2.4 Hydrologic Engineering

The Exelon Generation Company (EGC or the applicant) early site permit (ESP) site is located 6 miles (mi) east of Clinton, which is in DeWitt County in central Illinois, and is adjacent to the currently operating Clinton Power Station (CPS) Unit 1. Clinton Lake, an impoundment on Salt Creek, currently serves as the principal water source for the existing unit, which uses a once-through cooling system to dissipate heat from the turbine condenser. Water held behind a submerged dam constructed within the North Fork of Salt Creek in Clinton Lake provides the 30-day shutdown cooling water supply for the CPS Unit 1 ultimate heat sink (UHS). The applicant refers to this water source as the submerged UHS pond.

Figure 2.4-3 Proposed locations of ESP facility UHS intake and discharge

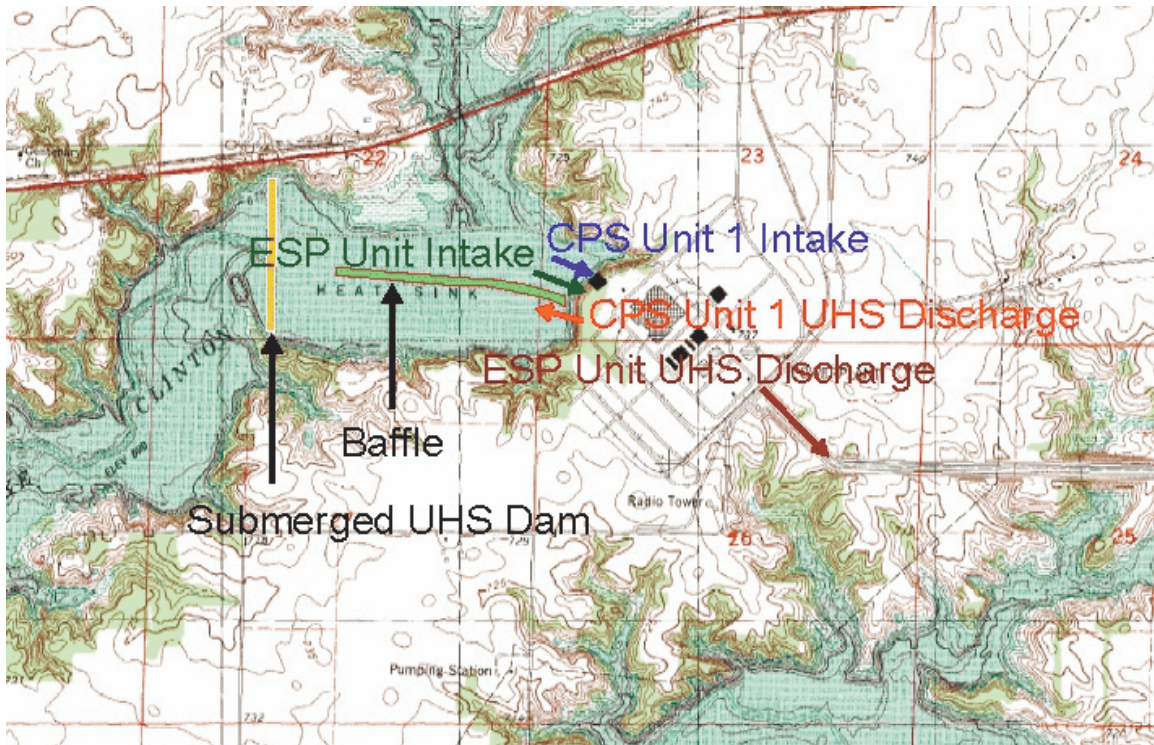
In Request for Additional Information (RAI) 2.4.1-1, the staff asked the applicant to provide survey coordinates (including elevations) for the bounding areas of all ESP facility safety-related structures, including intake tunnels and piping corridors. The staff also requested that the applicant provide coordinates of existing aquifers in bounding areas, particularly perched aquifers. In response to RAI 2.4.1-1, the applicant provided an updated figure to replace Figure 1.2-4 in Chapter 1 of the site safety analysis report (SSAR). The applicant stated that this figure shows the approximate location of safety-related structures, along with a grid system overlaid on the figure.

The applicant indicated that the safety-related structures for the ESP facility are the intake structures, the essential service water cooling towers, and some other structures that will be located within the ESP facility powerblock area. The applicant stated that the final sizes and locations of the safety-related structures will be determined after the selection of a reactor during the combined license (COL) application and construction phase and that no survey coordinates are established at the ESP stage.

The applicant stated that the location of the ESP facility's normal and UHS intake structures is approximately 65 ft south of the existing CPS intake structures. The applicant selected this location to route the ESP facility piping without disturbing the CPS shutdown cooling water piping that runs from the CPS UHS. The CPS piping exits to the east of the intake structures. The CPS nonsafety service water discharge and fire protection discharge exit near the north end and then turn northeast. The circulating water discharge piping exits the intake structures south of the service water pipe as a group of three pipes that combine into a single pipe, which then turns northeast to the turbine building. The circulating water piping for the abandoned

Figure 2.4-4 The watershed draining into Clinton Lake, delineated manually using topographic contours

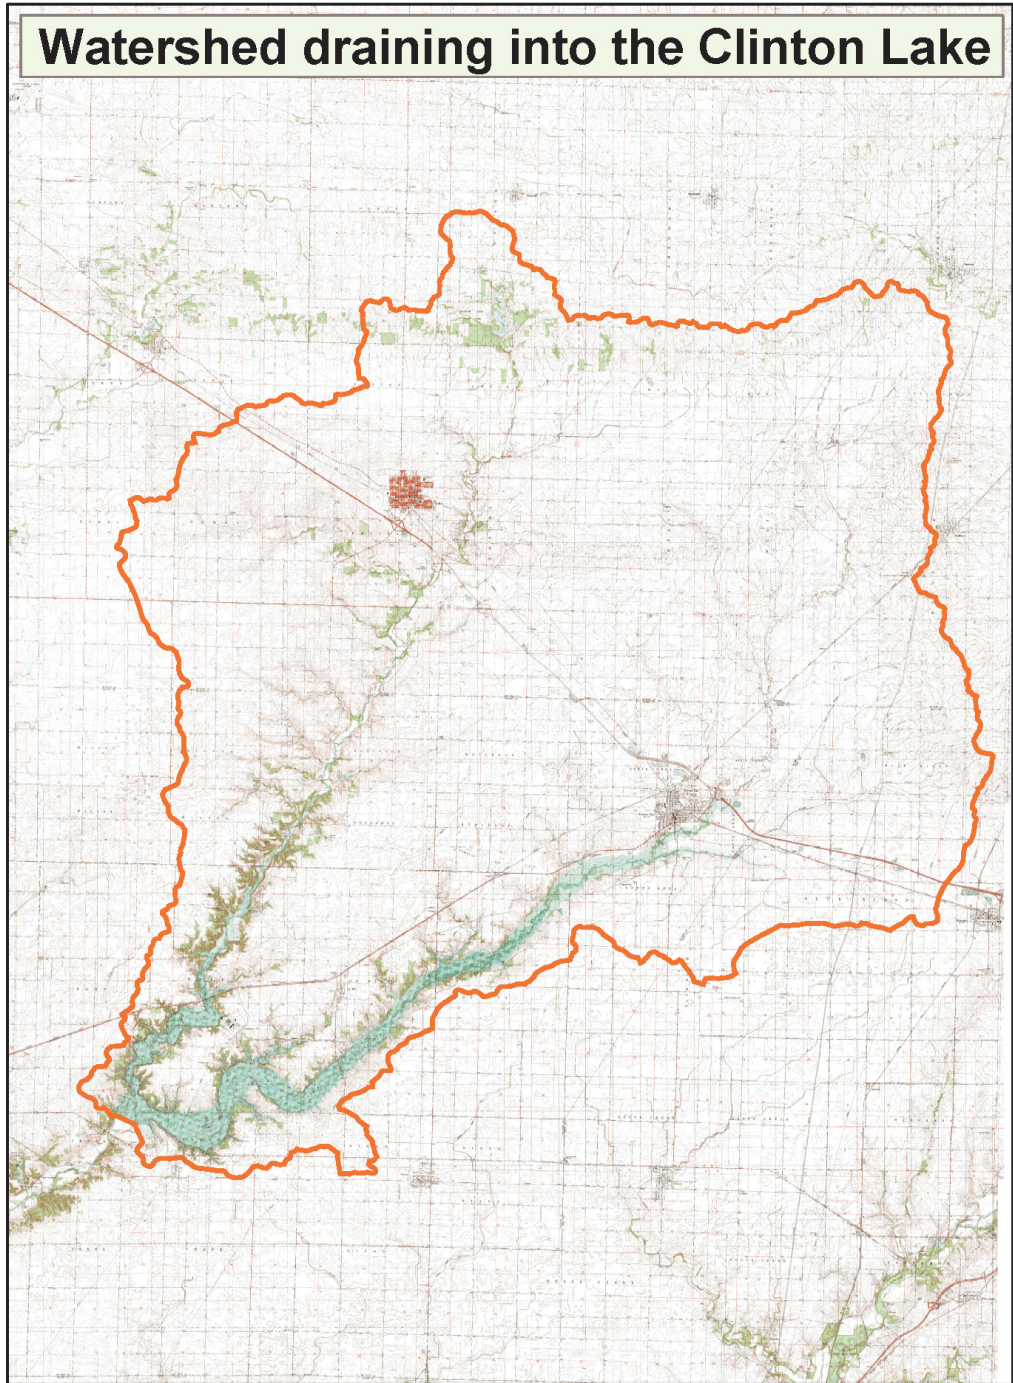
In SSAR Section 2.4.1.2, the applicant stated that the catchment area of Salt Creek above Clinton Dam is about 296 square miles (mi²). The staff manually delineated the watershed draining into Clinton Lake using USGS topographic maps (Figure 2.4-4 of this SER). The staff determined the area of the manually delineated watershed as 289.2 mi². The staff estimated the catchment area of Salt Creek above Clinton Dam to be approximately 2.4 percent less than that reported by the applicant.

Figure 2.4-6 Inflow and outflow from Clinton Lake during the PMF event calculated using the instantaneous-translation level-pool routing method

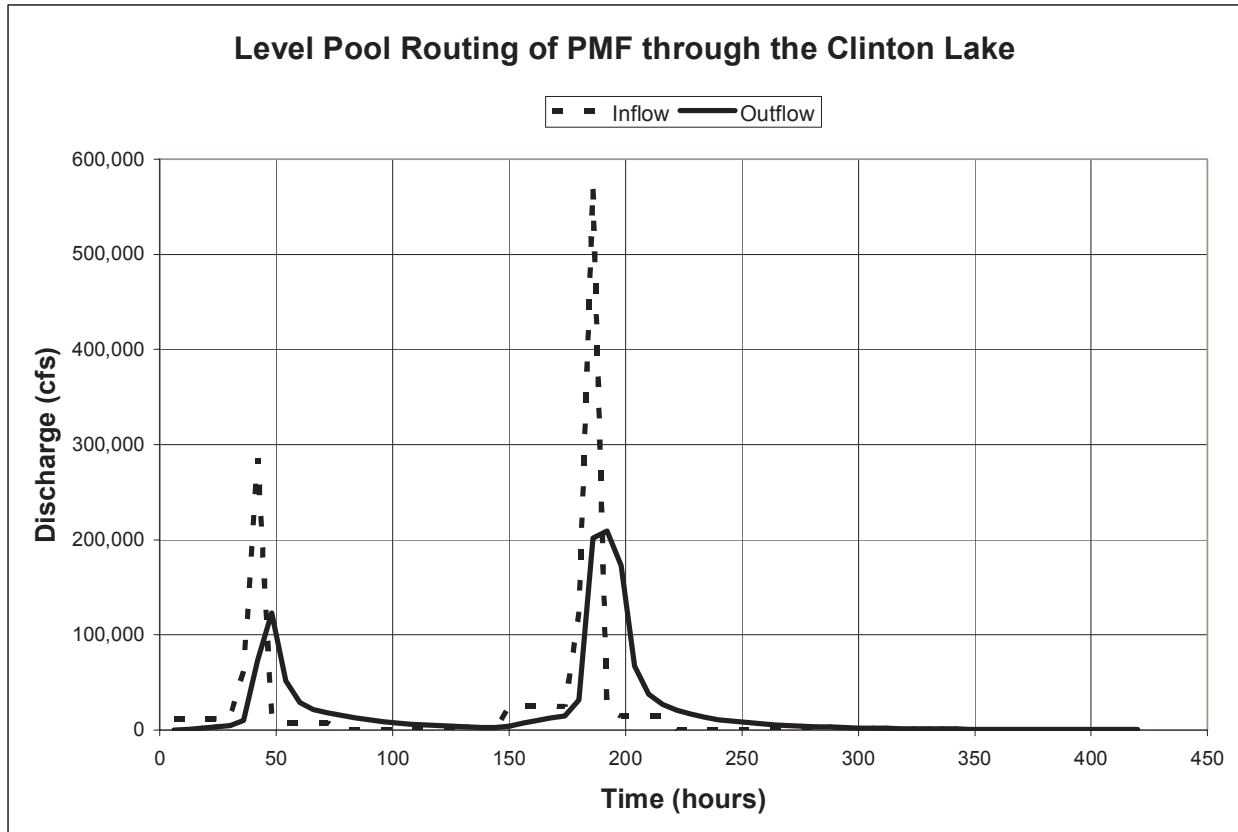
Results generated from the conservative, instantaneous translation, level pool routing method produced the reservoir inflow-outflow sequence shown in Figure 2.4-6 of this SER. Figure 2.4-7 of this SER shows the corresponding reservoir water surface elevations. The staff estimated the maximum hydrostatic (stillwater) water surface elevation using this extremely conservative and bounding approach to be 712.2 ft MSL.

Figure 2.4-10 Dawson Lake and Dam located approximately 17.1 miles north-northeast of the ESP site. Dawson Lake is located on the North Fork of Salt Creek.

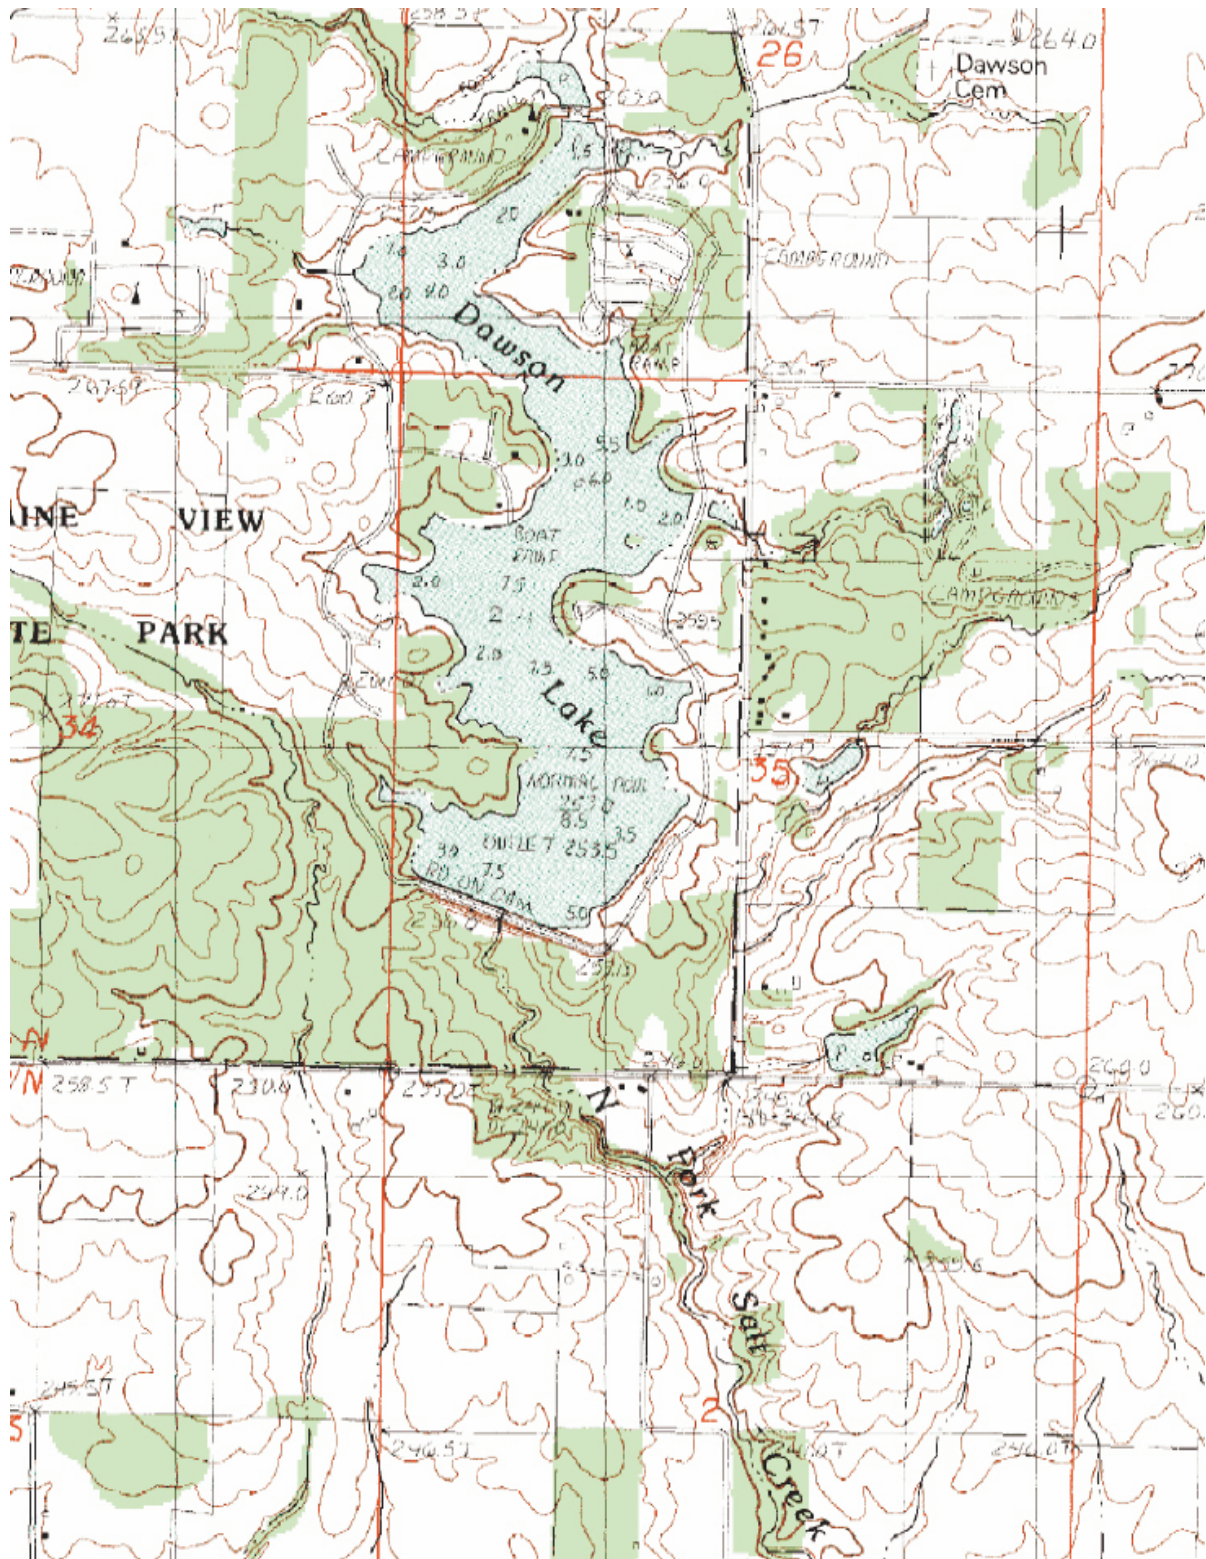
The staff determined that the maximum combined storage capacity of the two reservoirs upstream of Clinton Lake is 4446 ac-ft. The original capacity of Clinton Lake at normal water surface elevation of 690 ft MSL, as determined by the staff using the stage-storage relationship for Clinton Lake given in CPS USAR Figure 2.4-14, is 74,200 ac-ft. The maximum combined storage capacities of the two reservoirs upstream of Clinton Lake is about 6 percent of the normal storage capacity of Clinton Lake. The staff determined, using the same stage-storage relationship for Clinton Lake, that an increase in storage by 4446 ac-ft, with an initial water surface elevation in Clinton Lake of 690 ft MSL, would result in an increase in water surface elevation of 3.1 ft. This estimate is very conservative, since it ignores water discharged over the service spillway when the water surface elevation in Clinton Lake exceeds its crest elevation of 690 ft MSL. Discharge over the service spillway reduces the water surface elevation in Clinton Lake, and the final increase in water surface elevation resulting from a breach of the two upstream dams is likely to be less than 3.1 ft.

The staff's estimate of maximum water surface elevation in Clinton Lake because of PMF, wind setup, and wave runup, as discussed in Section 2.4.3 of this SER, is 716.5 ft MSL. The staff plans to include 716.5 ft MSL as a site characteristic in any ESP that might be issued for this application. Even if the maximum water surface elevation in Clinton Lake were to be augmented by 3.1 ft because of a breach of the two upstream dams, leading to a water surface elevation of 719.6 ft MSL in Clinton Lake, the ESP site, located at 735 ft MSL, would be safe from flooding. Therefore, the staff determined that the applicant's response to RAI 2.4.1-3 is satisfactory.

Figure 2.4-11 Clinton Power Station site and fetch length

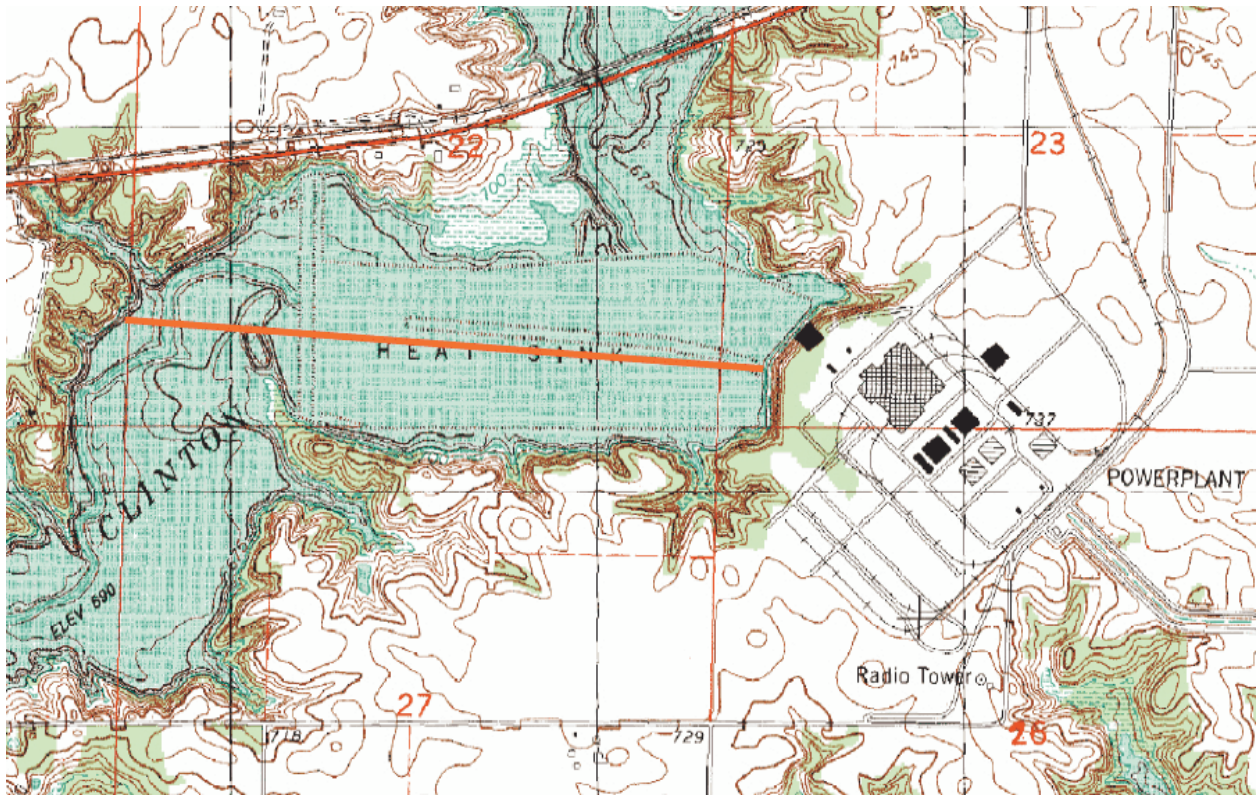
The following describes the staff’s independent evaluation performed to estimate seiche effects. Fetch length is one of the key parameters for determining wind setup and is generally based upon the longest straight-line distance from the site to the opposing shore. Although the site is approximately 3 miles from the dam and 10 miles from the upstream end of the reservoir, the longest straight-line distance to the opposing shore is approximately 6340 ft (see Figure 2.4-11 of this SER).

Figure 2.4-12 Stage-discharge relationship for Salt Creek at Rowell, IL

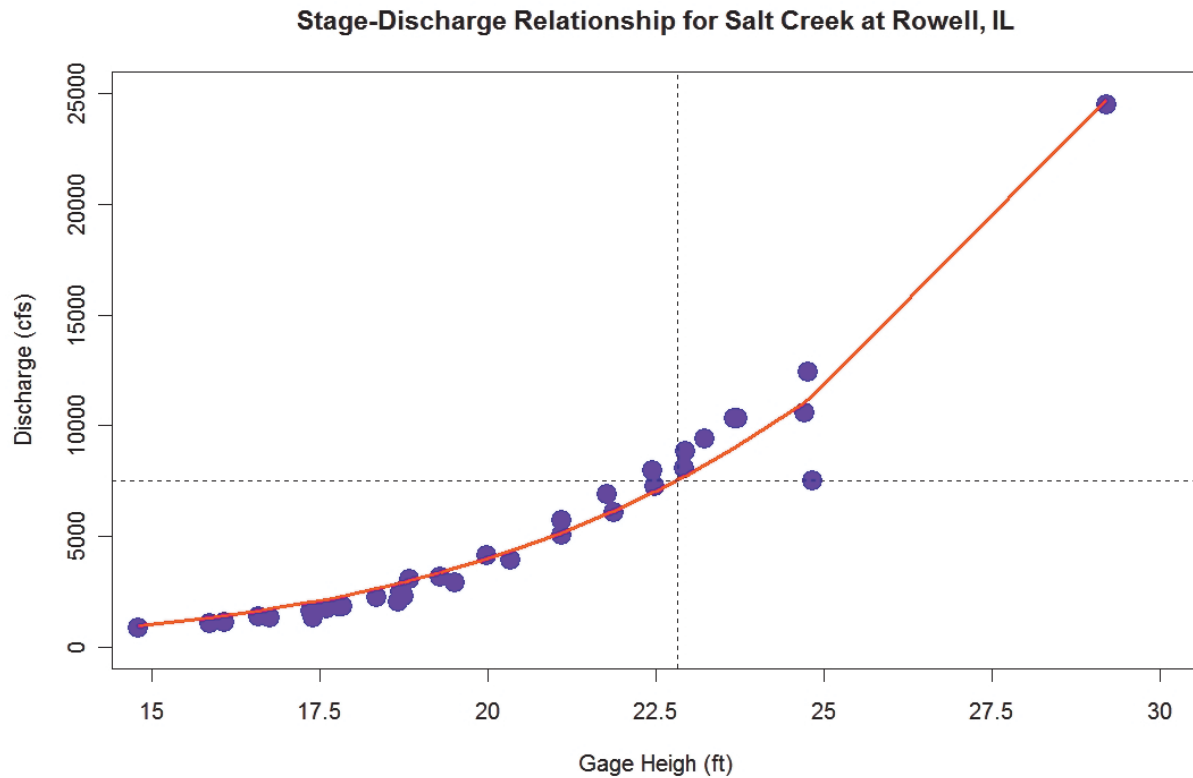
The staff prepared a stage-discharge relationship from available gauge heights for peak streamflow at the Rowell gauge using data from the period before the construction of Clinton Dam. Figure 2.4-12 of this SER shows this stage-discharge relationship. Using this relationship, the staff estimated a stage of 22.8 ft corresponding to a discharge of 7500 cfs, and an ice-jam-induced stage increase of 2.0 ft. If an ice-jam-induced flood were to augment the PMF, the maximum expected water surface elevation in Clinton Lake would be 718.5 ft MSL.

Figure 2.4-13 Accumulated degree-days since December 1, 1977, at the Decatur meteorologic station

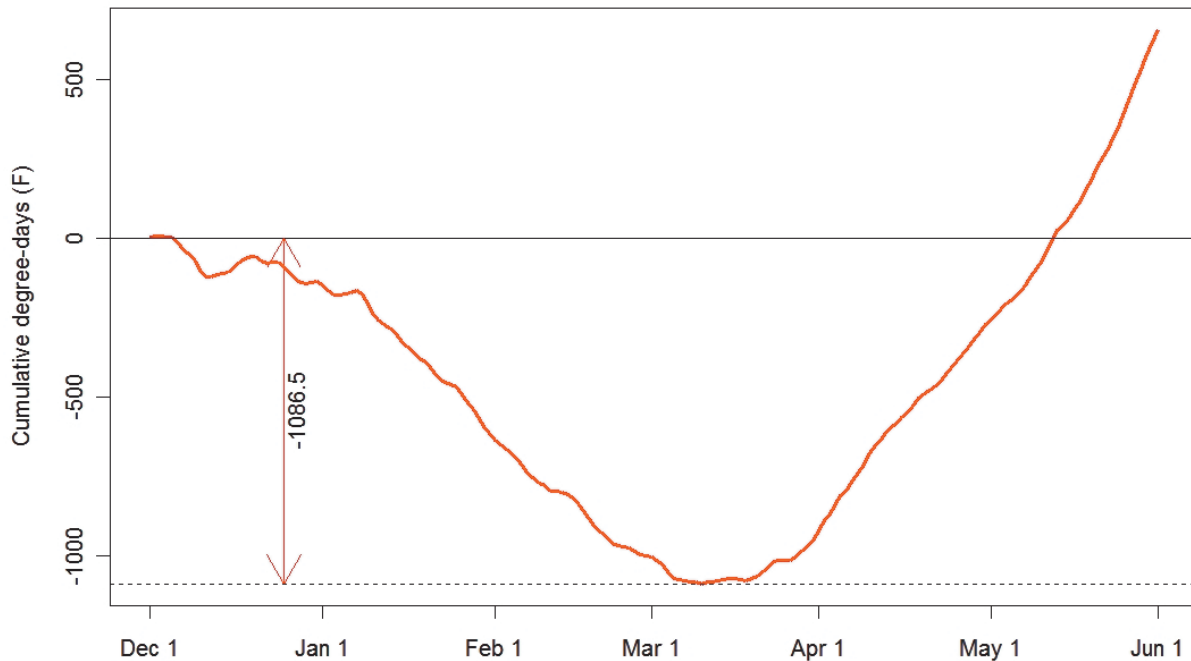
The staff independently estimated the likely surface ice thickness that might form near the intake structures. During this estimation, the staff used mean daily air temperatures recorded at the Decatur, Illinois, meteorologic station. Maximum and minimum daily air temperatures at this station are available for water years 1902 to 1999. The staff estimated cumulative degree-days starting December 1 through May 31 for each water year. The most severe cumulative degree-days below freezing occurred in water year 1978 (see Figure 2.4-13 of this SER).
